Technical change to SIHA 3

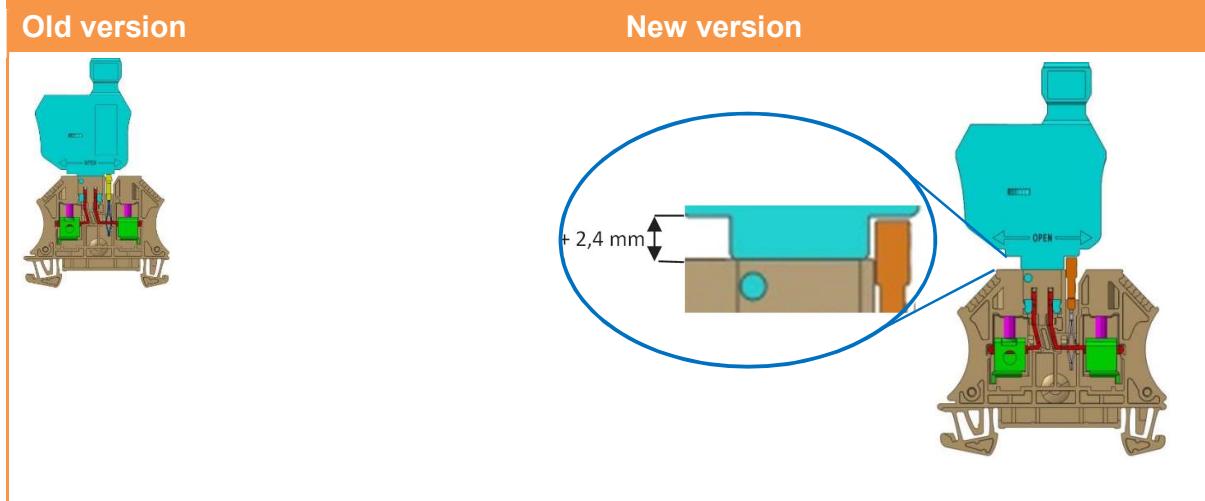
Height:	increased by 2.4 mm
LED version:	LLC (low leakage current)
Neighboring disconnect terminal:	it is easier now to open its disconnect lever
Unique identification of the "new" SIHA 3:	engraving "2018" black moulding

The fuse holder SIHA 3 has been modified, as the pluggable cross connection for the A series is 2.4mm higher, due to the target to get only one pluggable cross connection ZQV...N for the A series & the W series.
